APPLICANT RESPONSE
TO REVIEW COMMENTS

TECHNICAL REVIEW COMMITTEE (TRC) COMMENTS:

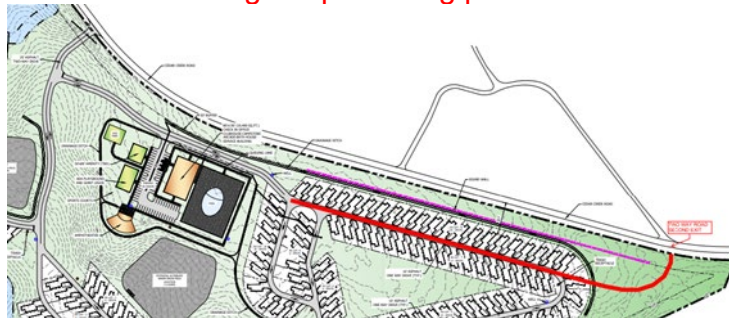
- There are 166 camper sites in this proposed project with one way in and one way out. This does not seem safe or efficient.

- Per NFPA 1194 Section 5.1.1.4.1 the AHJ has authority to request multiple entrances. If required one option would be per the sketch below (possible changes indicated in red). Final design/layout to be coordinated during the permitting process.

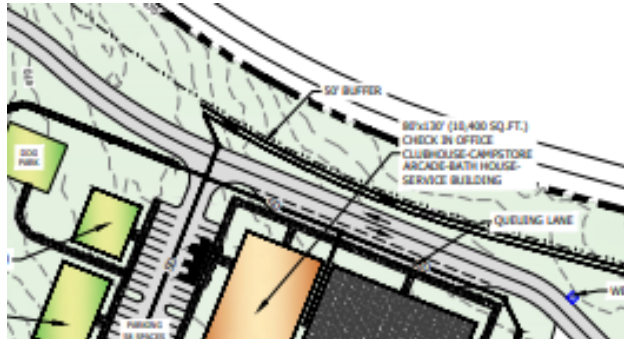
- The roads seem narrow and have tight radii for a RVs to travel and maneuver on
 - Per NFPA 1194 Section 5.1.2.4 the turning radii for RV campgrounds shall be

- The one-way road system could be laid out in a better way to keep vehicles from traveling around long loops to access. For example- a camper checks in at the office and must circle the entire loop on plan east to get back to the areas plans west or south of the amenity.
 - The one-way layout is typical of RV campgrounds.
- There doesn't appear to be an area for RV parking at check in office. How will traffic work when someone in an RV is checking in?
 - Queuing lane is indicated on the site plan adjacent to the Check-in Office. It is a third lane for approximately 230'. It is a little hard to see on the drawing.

not less than 30'. Also, the provided road width is greater than the minimum required per NFPA 1194 Section 5.1.2.

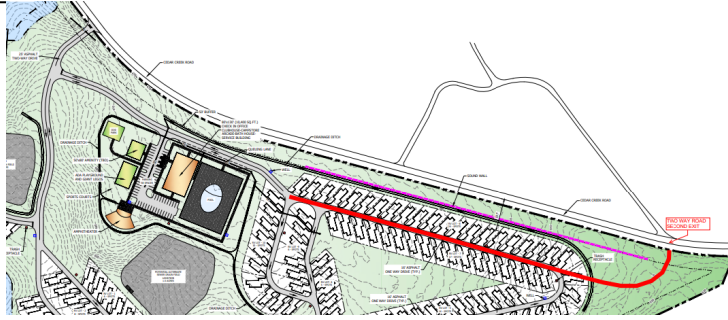
- All roads serving a fire apparatus access roads must be 22 feet in width.
 - NFPA 1194 Section 5.1.2.2 states an accessory road to be 20'. If Lancaster AHJ requires 22', the sketch plan shall be revised in design.

- If no public water supply is available for firefighting an alternate means of water supply must be provided.
 - The site is planned to maintain well water supply. A fire supply water tank and pump will likely be designed to meet fire protection requirements.

- An approved fire apparatus access road must extend to within 150 feet of all sides of all buildings.
 - Fire apparatus access roads extend to within 150' of all buildings.

- More than one entrance/ egress point will be required for more than 100 units.
 - Per NFPA 1194 Section 5.1.1.4.1 the AHJ has authority to request multiple entrances. If required one option would be per the sketch below (possible changes indicated in red). Final design/layout to be coordinated during the permitting process.

- Provide an auto-turn movement model showing a firetruck is able to negotiate turns.
 - Auto-turn movement modelling will be completed during design.
-
